WTC DRAWING  
BOOK 19  
AB-1-K-1055

SKILLING, HELLE, CHRISTIANSEN, ROBERTSON

PROJECT	THE WORLD TRADE CENTER	TITLE	DRAWING BOOK 19 - REVISIONS AFTER FABRICATION	DATE	5/18/73
---------	------------------------	-------	---	------	---------

1. The details given in Book 19 define revisions to be made to previously fabricated steel members, or to members under fabrication.
2. The location of such revisions and the detail number are shown in Structural Steel Plans, using the following symbol:

TITLE CORE COLUMN REINFORCING FL 98-106

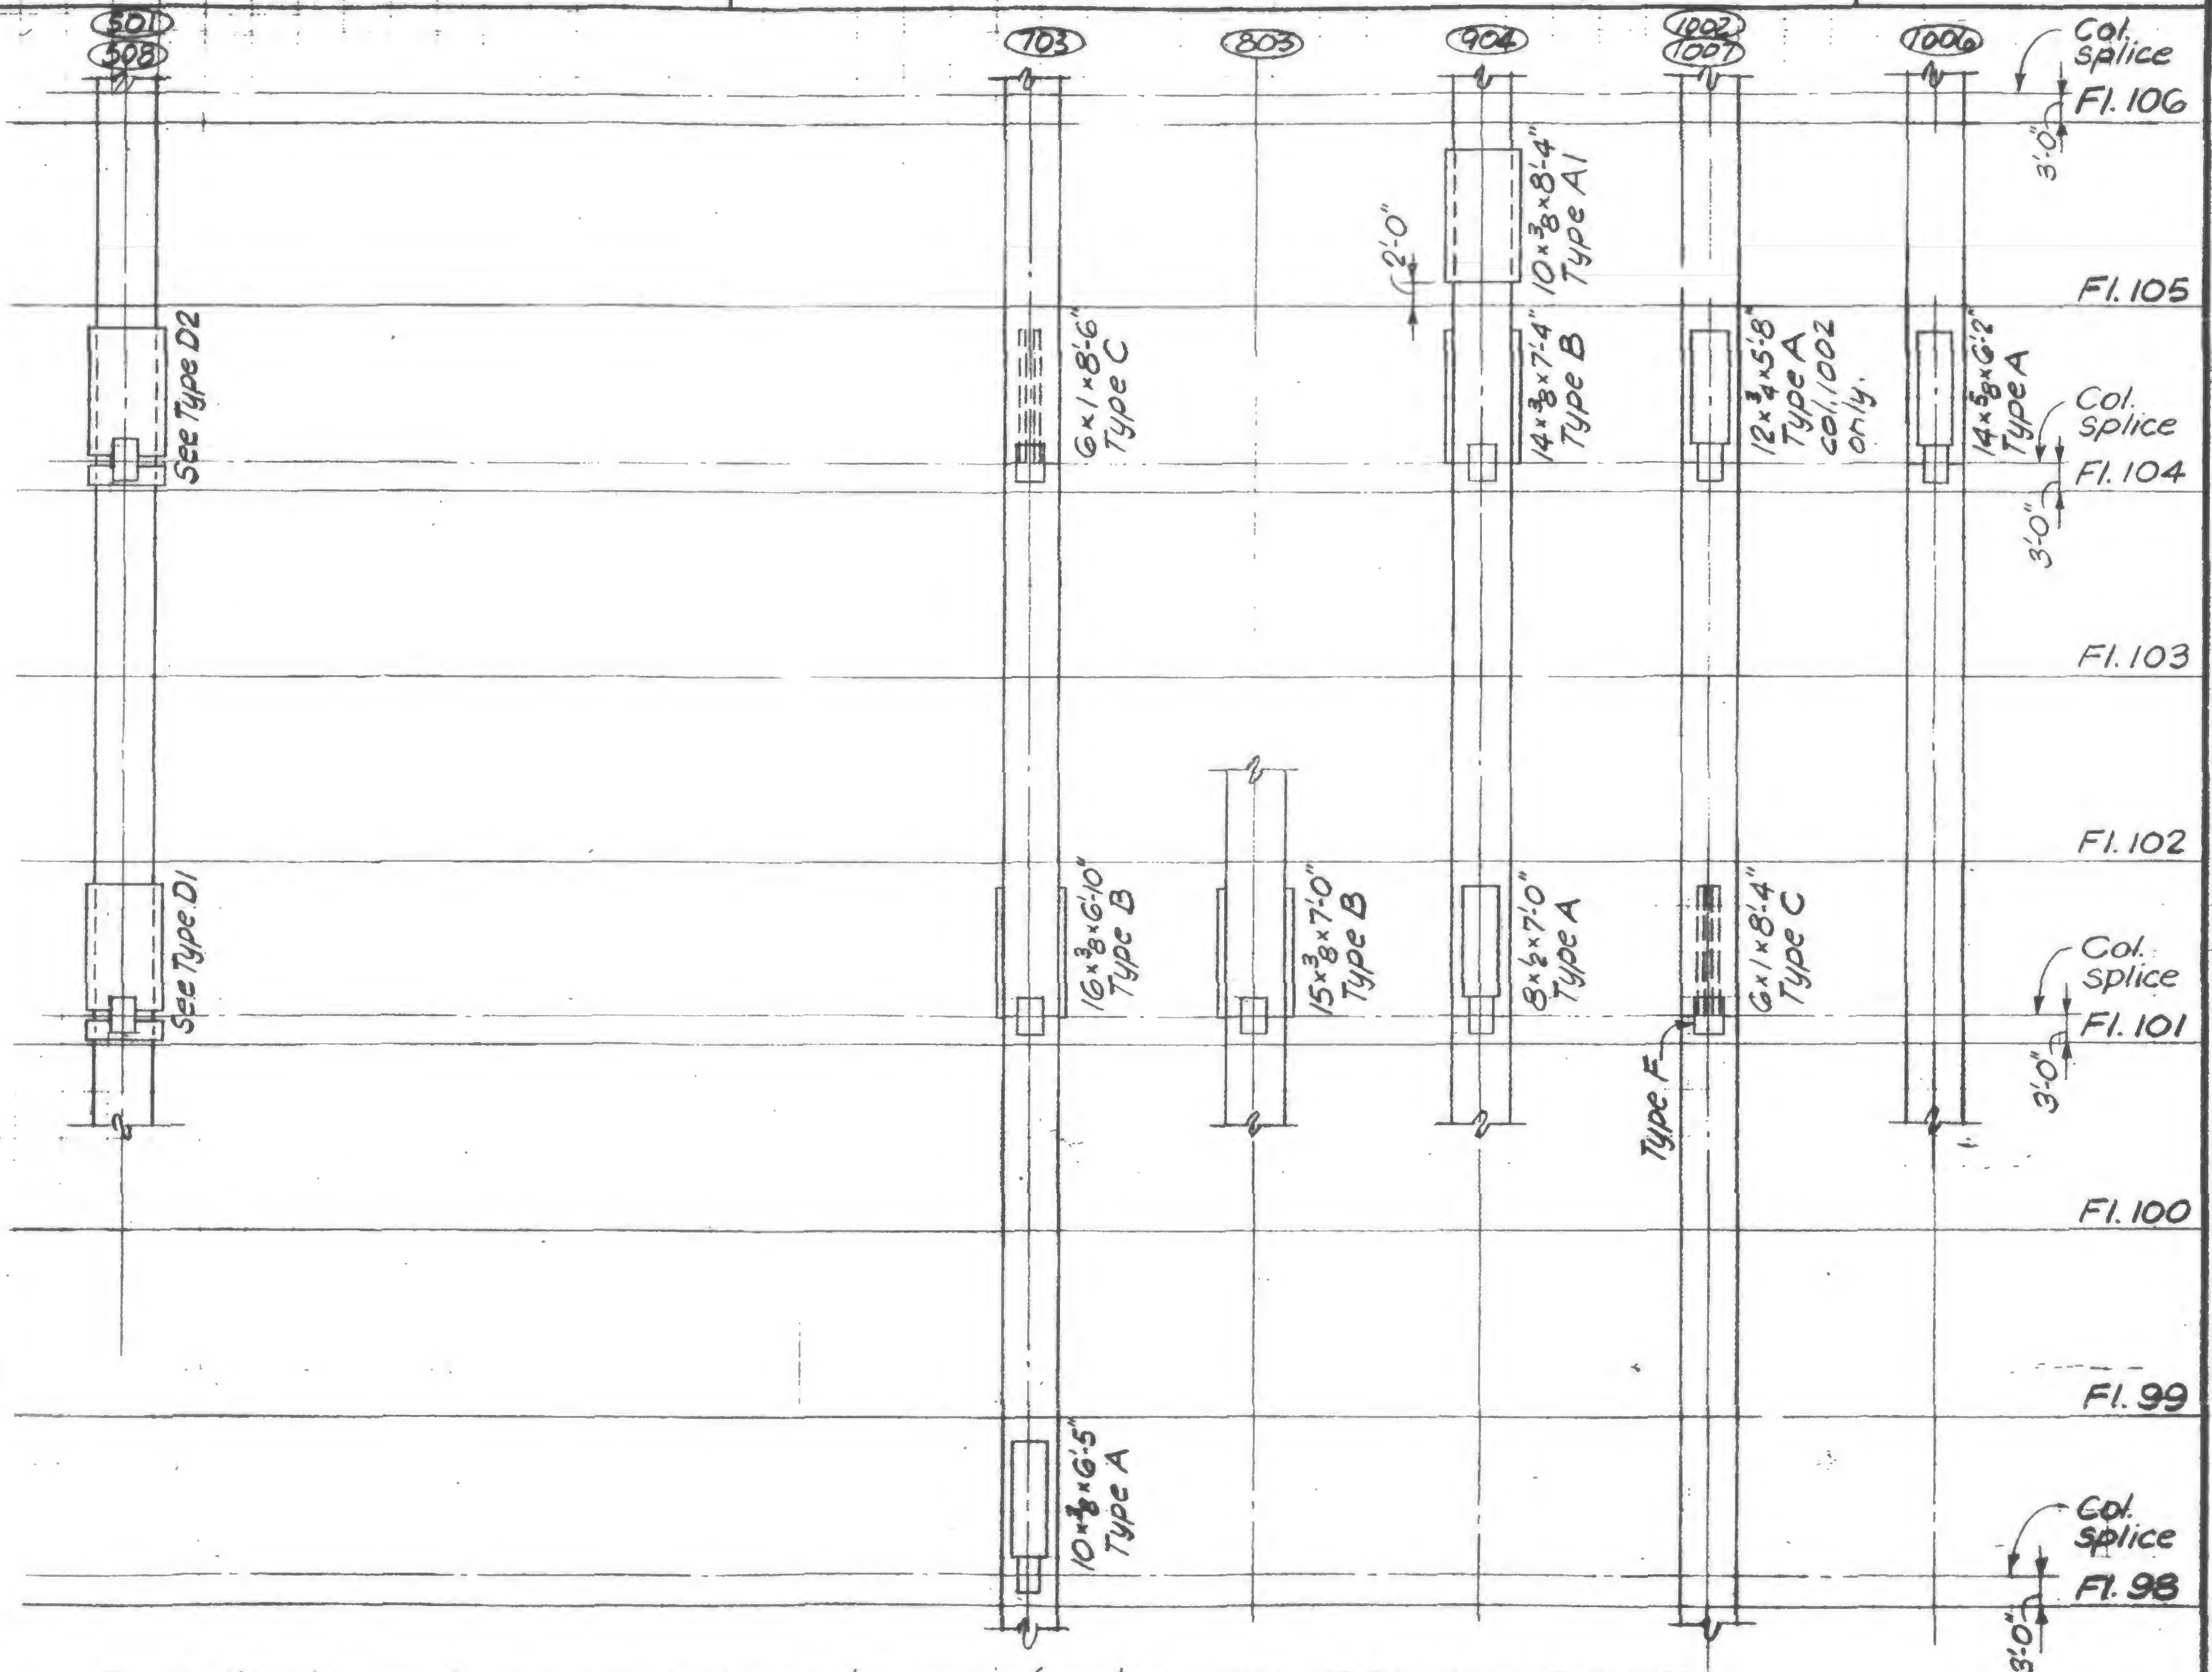
The following columns do not require reinforcing: 502, 503, 504, 505, 506, 507, 601, 602, 603, 604, 605, 606, 607, 608, 701, 702, 704, 705, 706, 707, 708, 801, 802, 804, 805, 806, 807, 901, 902, 903, 905, 906, 907, 908, 1001, 1003, 1004, 1005, 1008.

Reference Dwg: 6-AB2-30

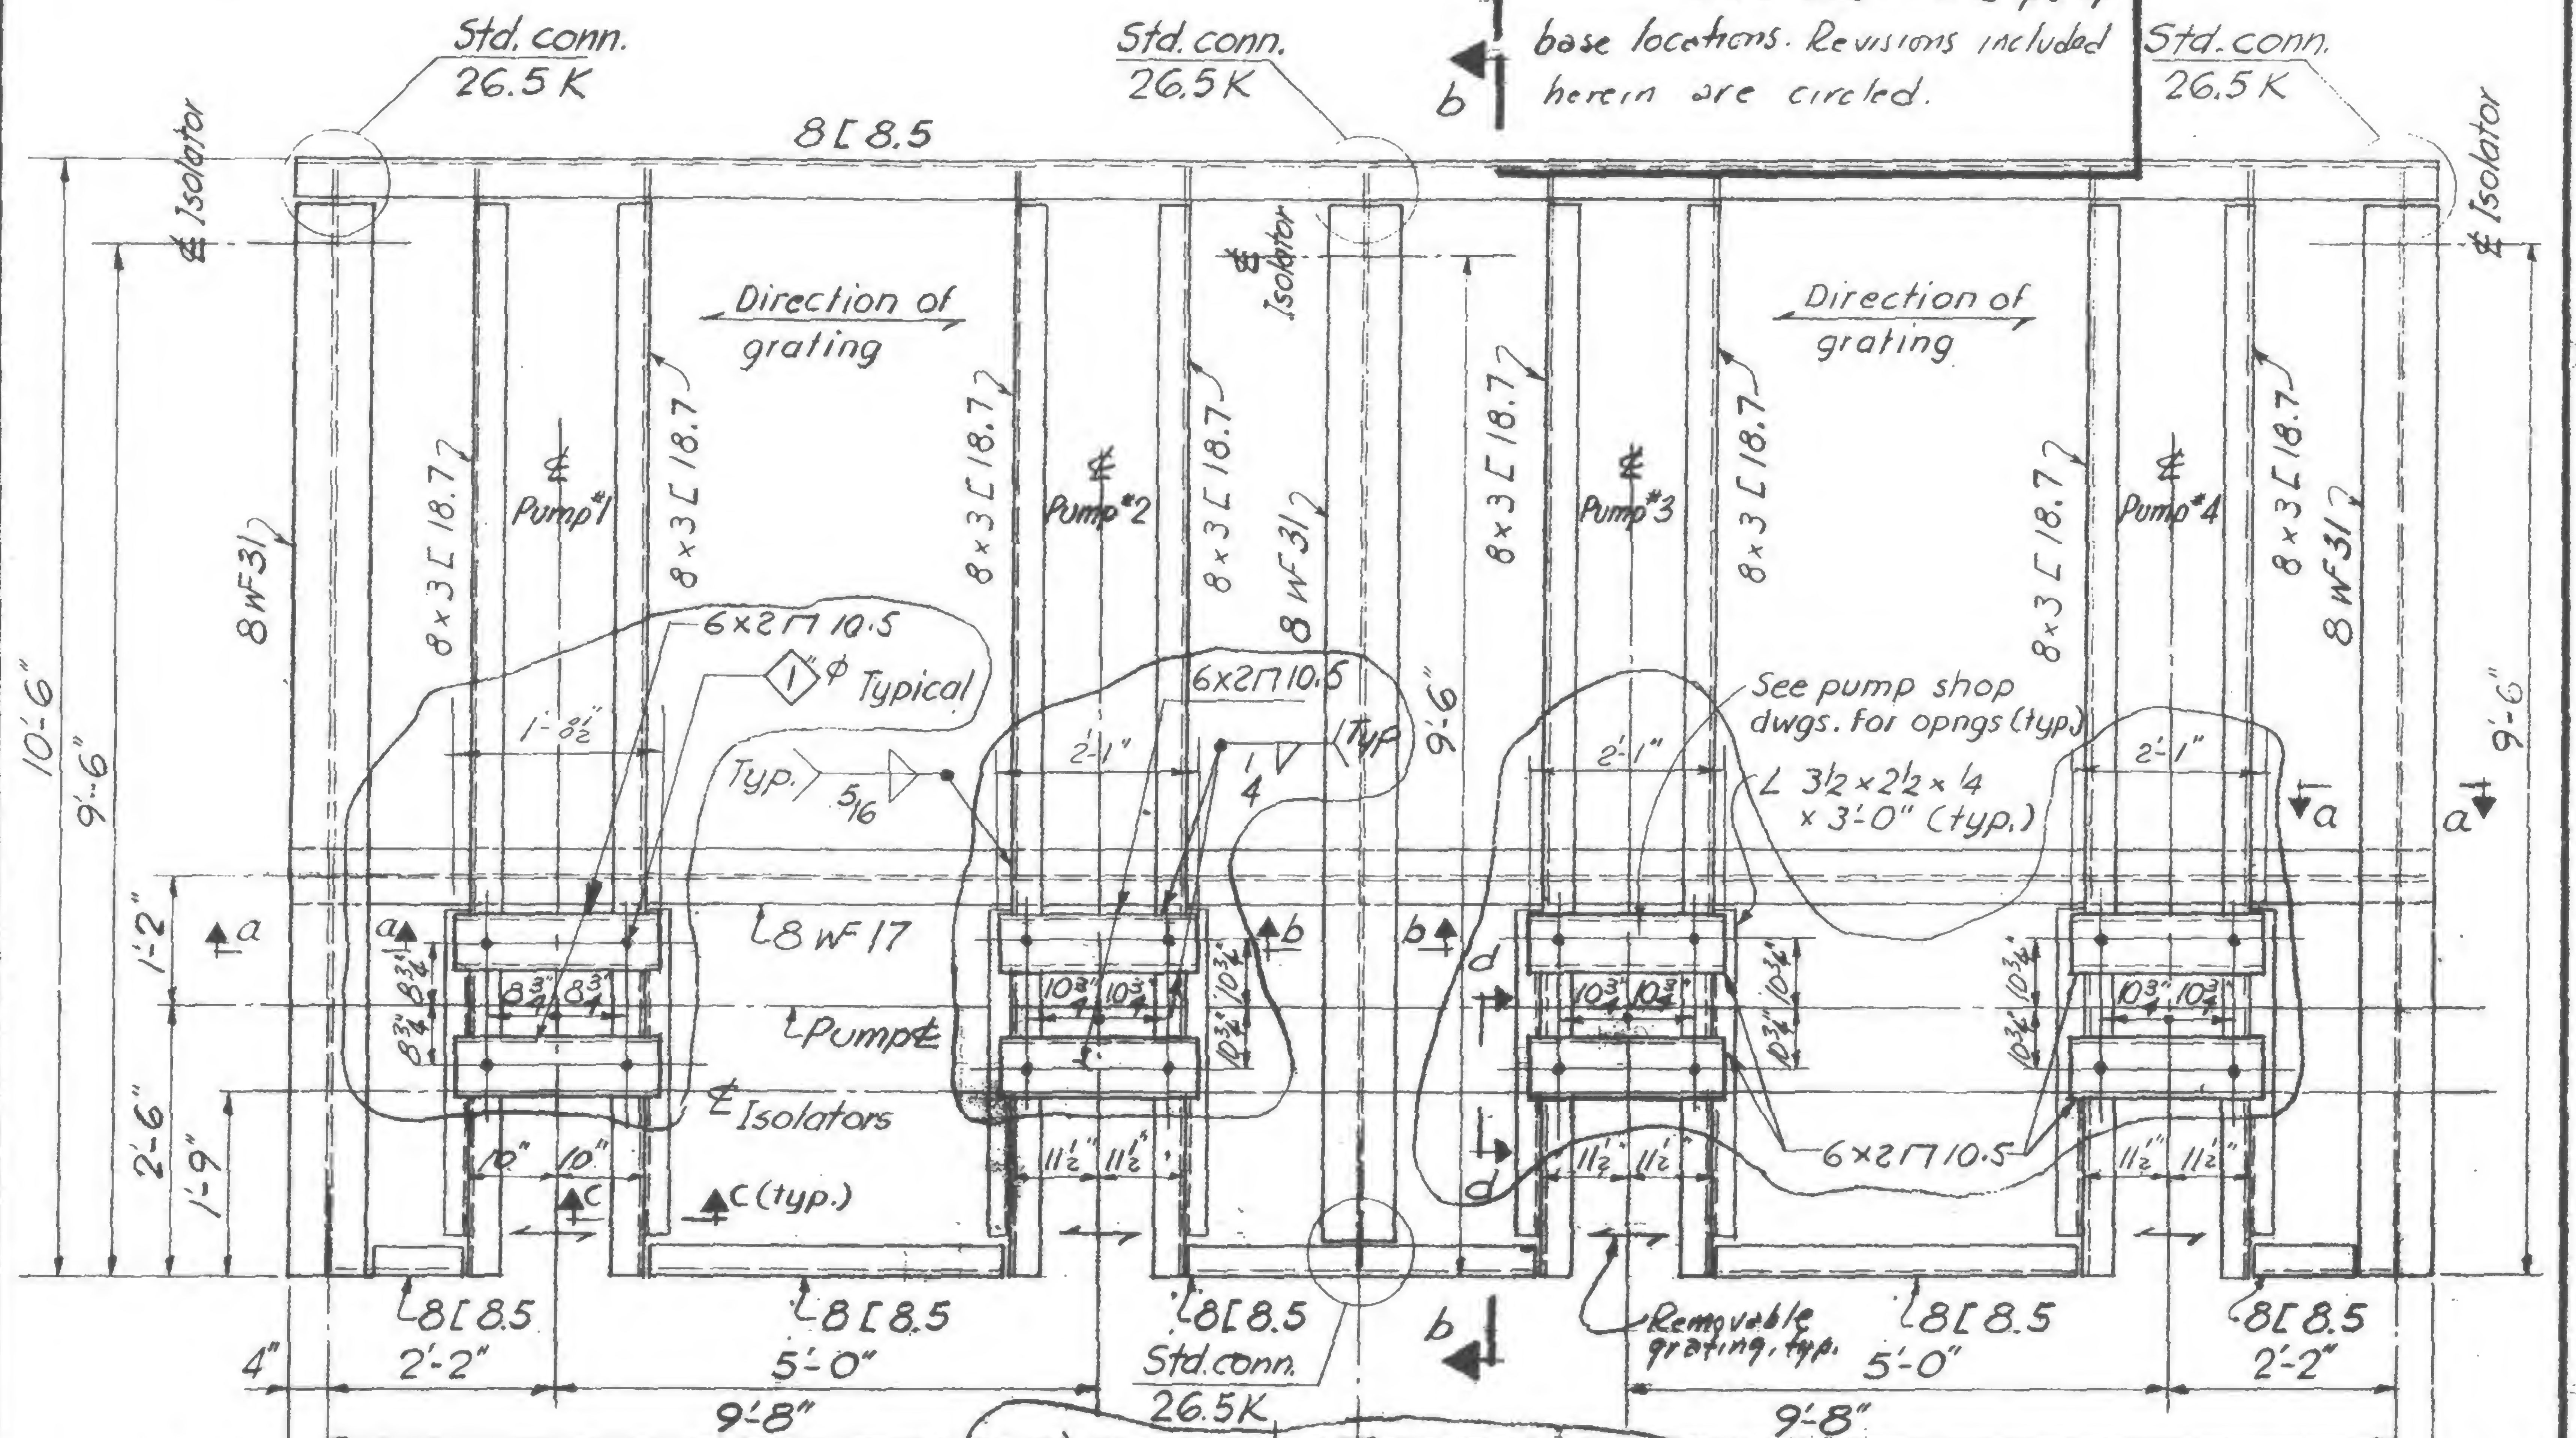
- ① Provide new 6x4x3/8 L and end clips. Connect to support Ls by field welds as shown.
- Revised pump bolt locations.

19-AB-1011

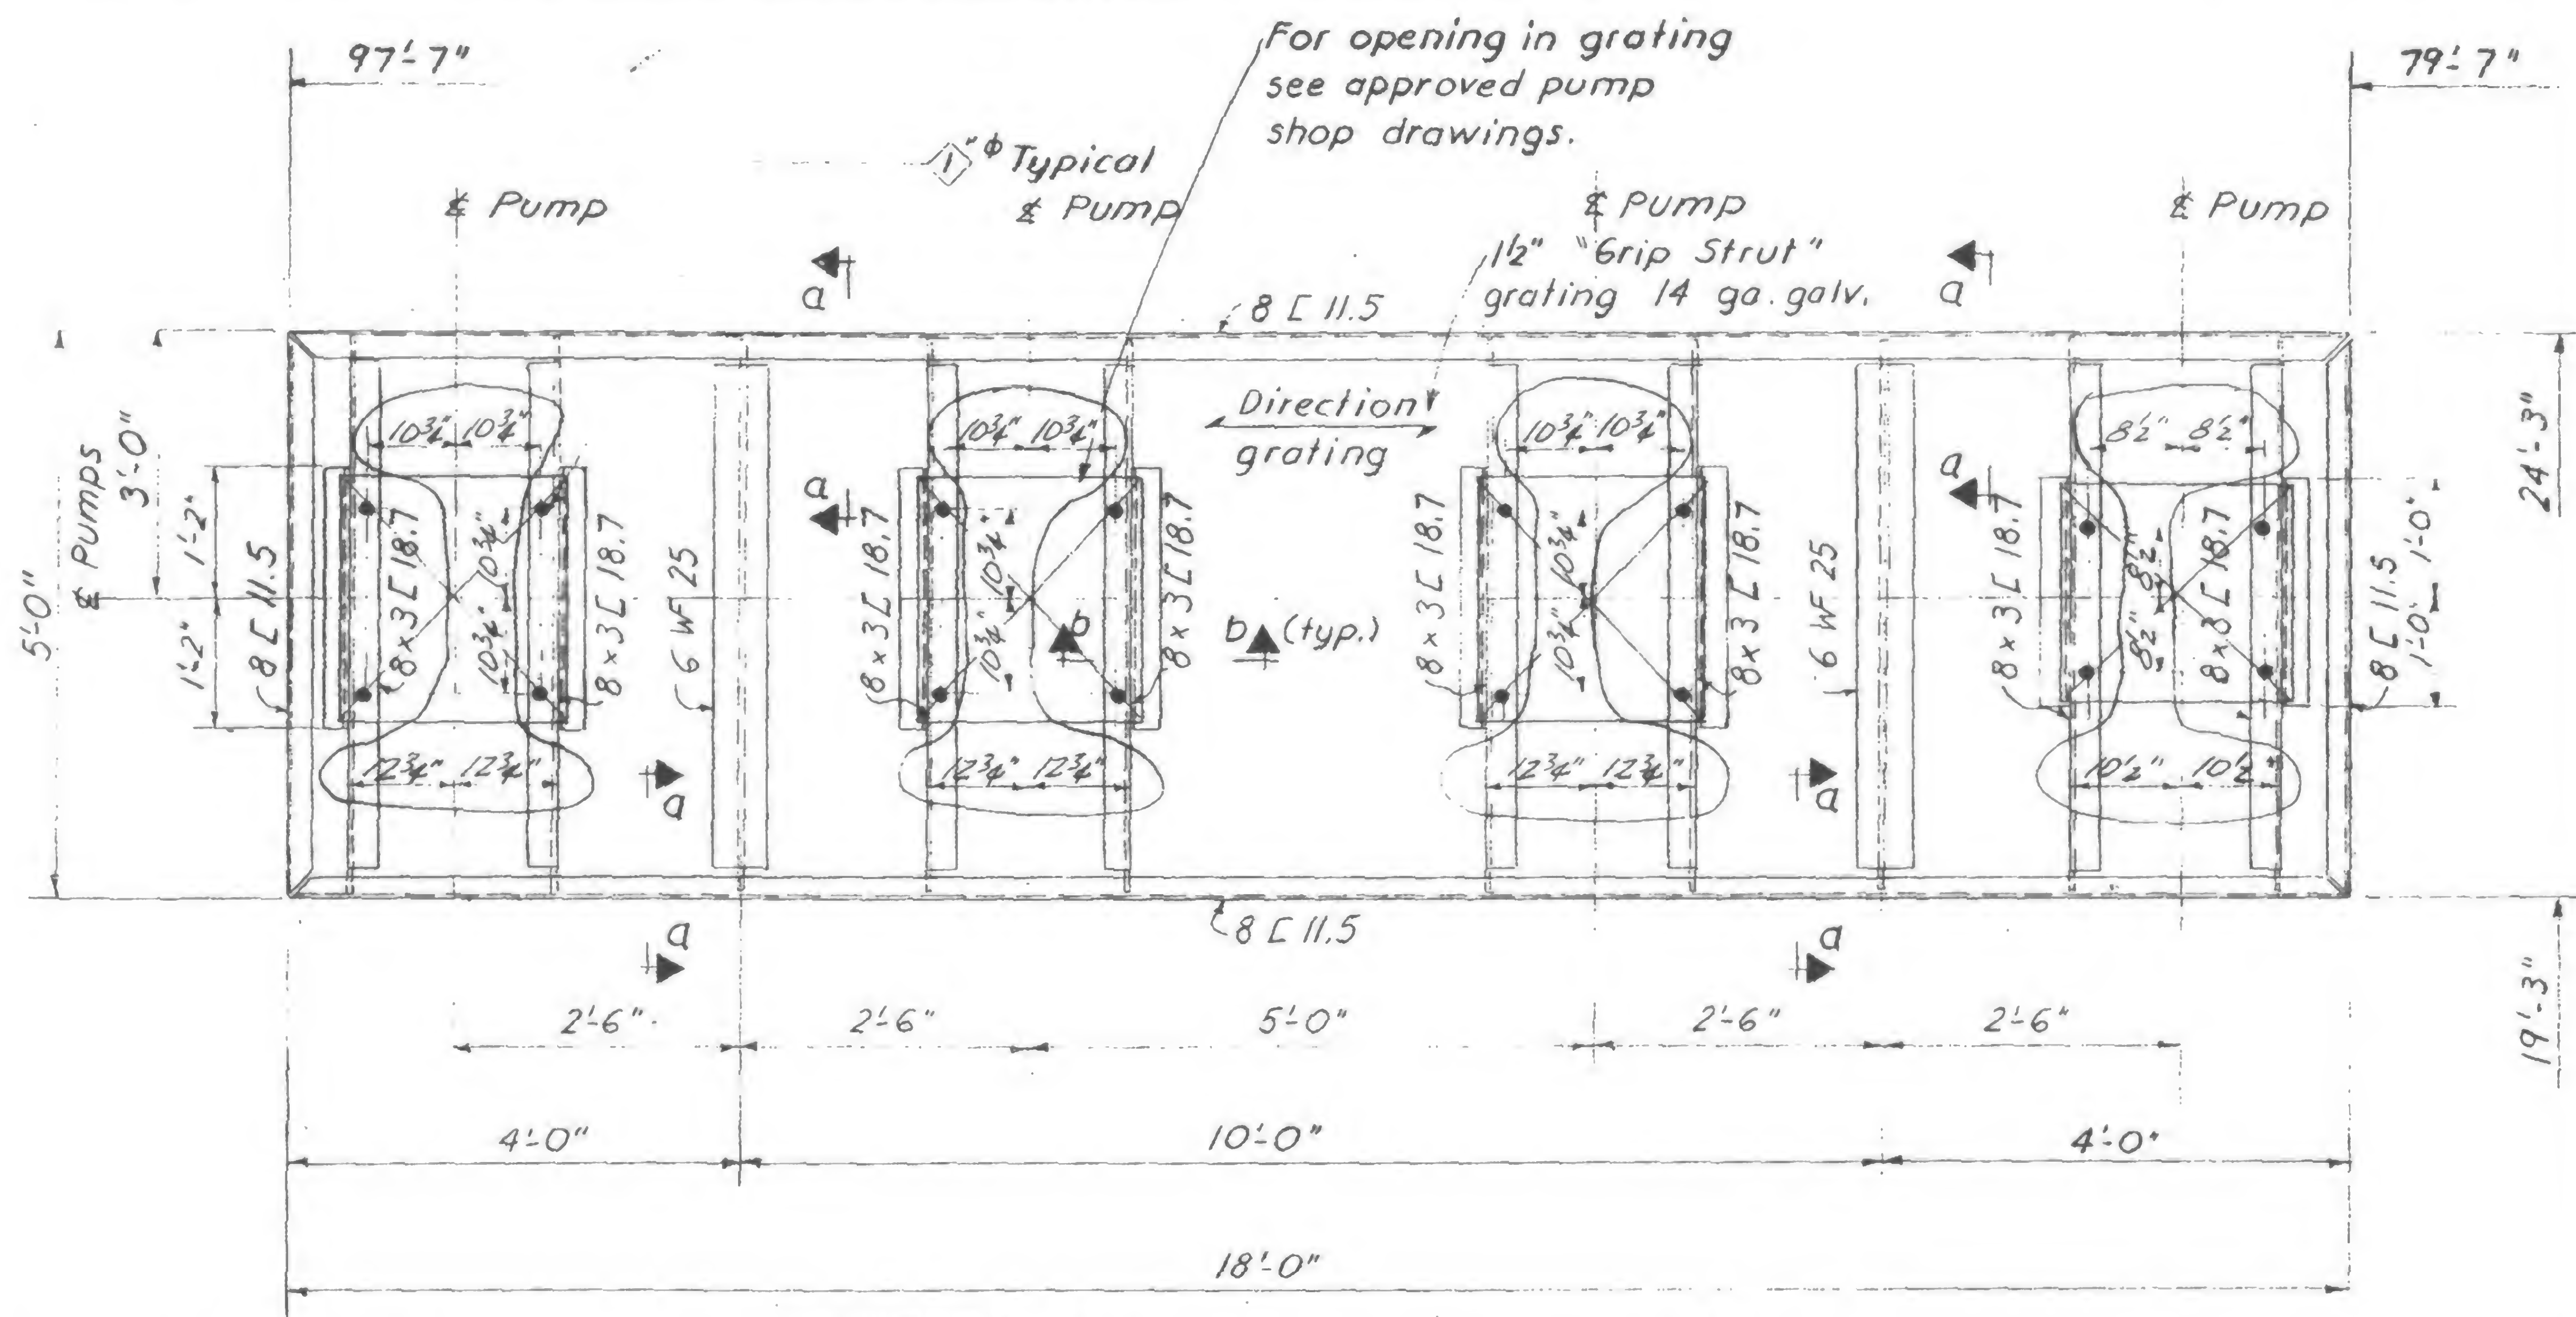
Revision work:  
 Revised pump bolt locations Connect relocated members by field welding as shown.
